Sub: Modification in Environmental Clearance granted for Parsa East & Kanta Basan opencast mine (10MTPA) and Pit Head Coal Washery (10MTPA) of M/s Rajasthan Rajya Vidyut Utpadan Nigam Limited.

Proposal for modification in Environment Clearance letter conditions for Interim Washery at Parsa East & Kanta Basan Coal Blocks

PROCESS Flow Sheet of Barrel Washing Circuit for interim Washery

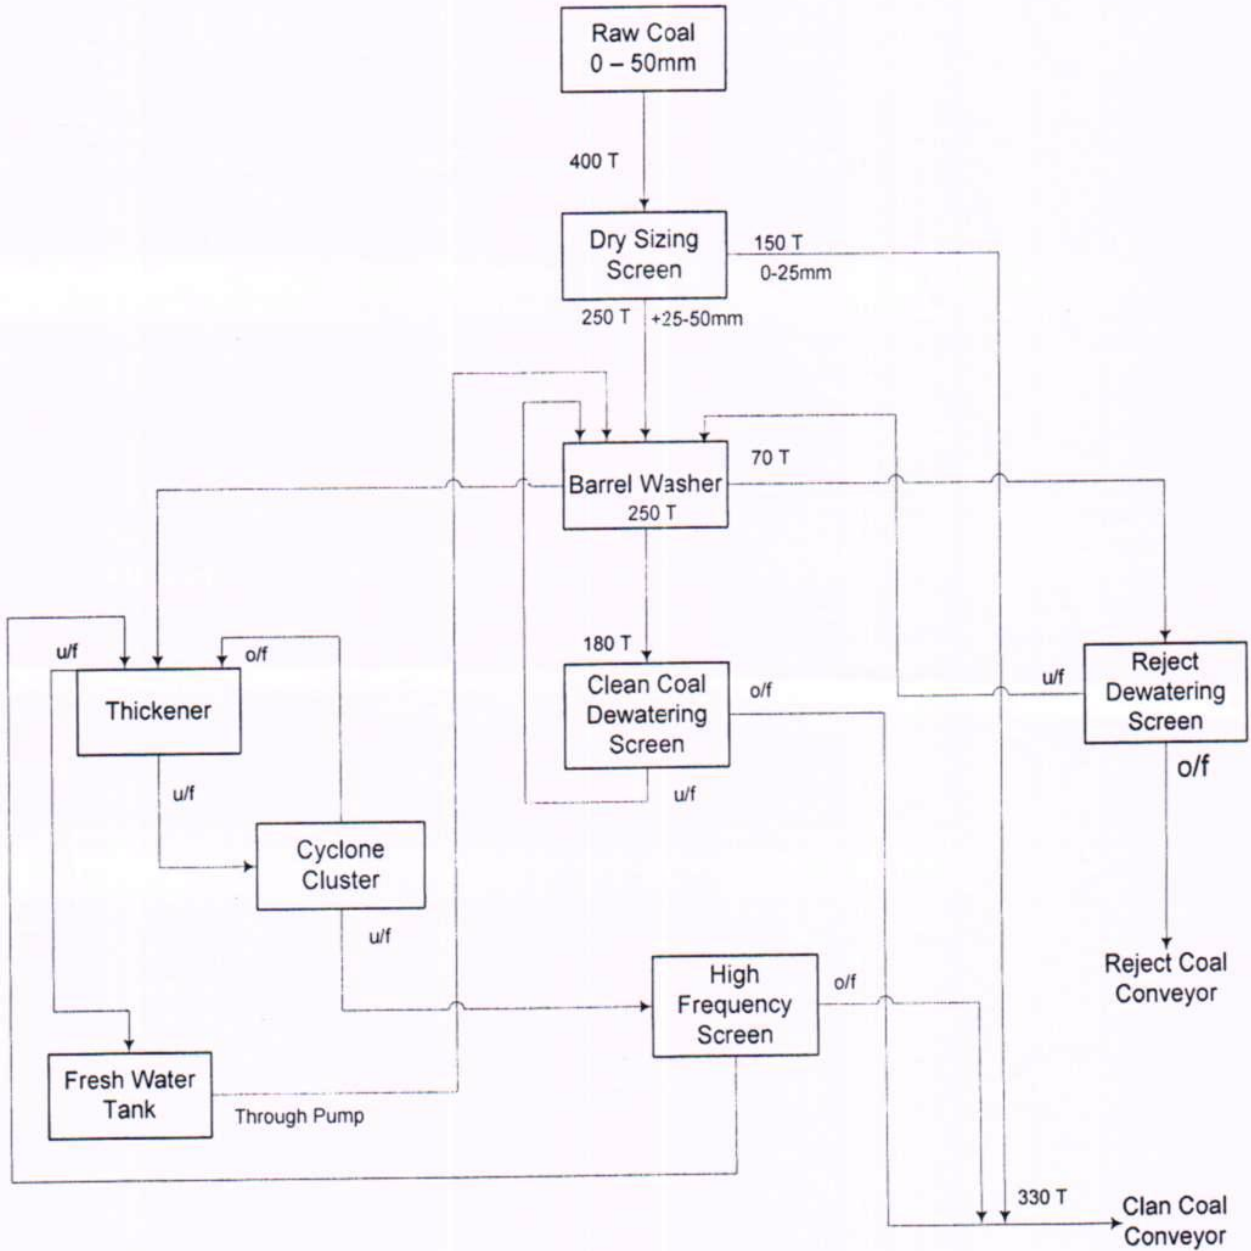
- a) Coal production from the block will commence from October 2012. The linked power plants will be commissioned in December 2012. Therefore, clean coal supply is to start sometimes in October 2012. The main coal washery based on Jig washing technology is scheduled to be commissioned in August 2013.
 - b) Barrel washing system is among the simplest coal washing method with minimum additional equipment and the least gestation period.
 - c) Erection and commissioning of Barrel Washing system can be achieved in 3 to 4 months.
 - d) As per the commissioning schedule of the linked power plants, the requirement of coal is 2MTPA during 2012-13 which matches with the first year's coal production from the mine.
2. A lay-out plan and process flow sheet of interim washery are enclosed at Annexure I and Annexure-II.

Coal from mine will be crushed to 50mm size through crushers and then the raw coal of size 0-50mm will be first dry-screened at - 25mm and oversized of 25-50mm will be fed to Barrel Washer for washing. The fines of size - 25mm consists of nearly 30% ash and hence is directly conveyed to clean coal product.

Barrel will be producing 2 products viz., clean coal and coal rejects after washing. The rejects will be first de-watered and then conveyed to Reject Bin, whereas clean coal will after de-watered will be conveyed to clean coal bin along with -25mm screened fines for loading and dispatching. The rejects will be unloaded to Rejects stock.

The overflow water from Barrel Tank will be fed to a small Thickener and its underflow slurry fines will be recovered through Hydro-Cyclone and HF Screen and fed to clean coal conveyor.

WATER FLOW DIAGRAM OF INTERIM WASHERY

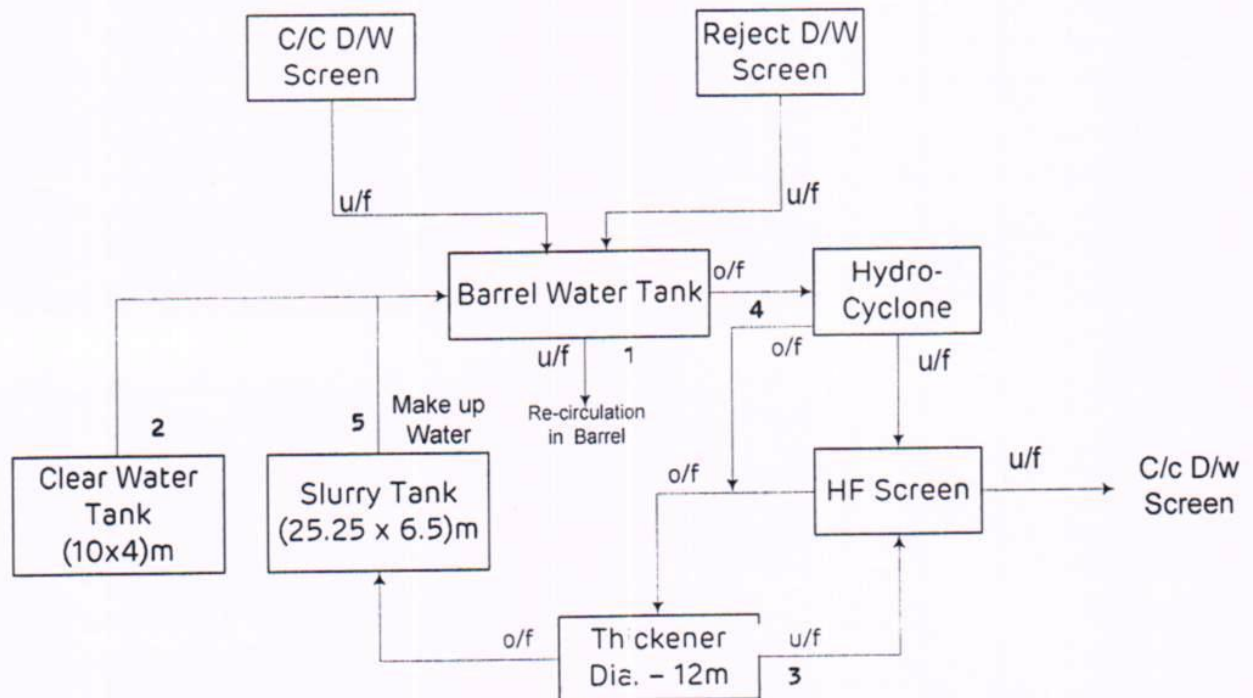
The circuit comprises of close loop water cycle and no effluent discharge outside plant will take place.

- (i) The washery will adopt close water circuit. (Annexure -III)
- (ii) For recovery of water from the slurry, it is proposed to provide hydro- cyclones, high frequency screen and a thickener. The recovered water will be reused in the washing process. Four emergency slime ponds are also proposed. These measures will ensure zero effluent discharge.
- (iii) Crusher and screening area in CHP will be provided with dry fog/mist type dust suppression system.
- (iv) All transfer points will be provided with dust suppression system.
- (v) Coal from the CHP to the washery will be transported by covered belt conveyors.
- (vi) Haul and surface road will be regularly sprayed with water.
- (vii) Rain guns will be installed in coal stock yards.
- (viii) Green belt will be developed using local plant species.
- (ix) Good maintenance of CHP area will be ensured.
